May 2019  
Hakko Electronics Co., Ltd.

**MONITOUCH V9 series**

**Notes on revision of hardware version**

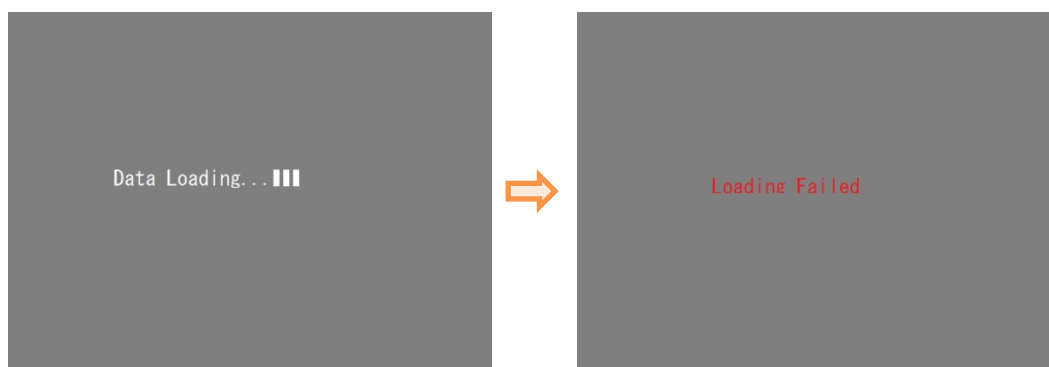
**3. Reason of revision in the hardware version and the OS version**

Alteration of the circuit board due to end of manufacture of some components

[Manual upgrade]

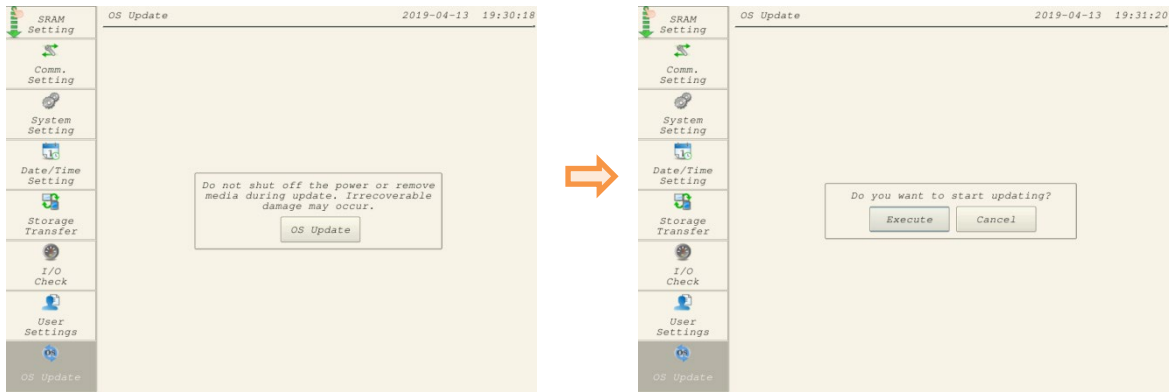
- \* The OS versions which do not support hardware version "f" or later (V1.00 to V3.4x) are not installable on the V9 of hardware version "f" or later.  
Please use the OS V3.50 or later for the hardware version "f."  
If installing on unsupported hardware is attempted, for example, installing the OS V3.40 on the V9 of hardware version "f", the following message will appear.

Go to [OS Update] and press [Execute]. The V9 will give three short beeps.

When pressing [Cancel], you will see a message "The OS cannot be updated to this version."
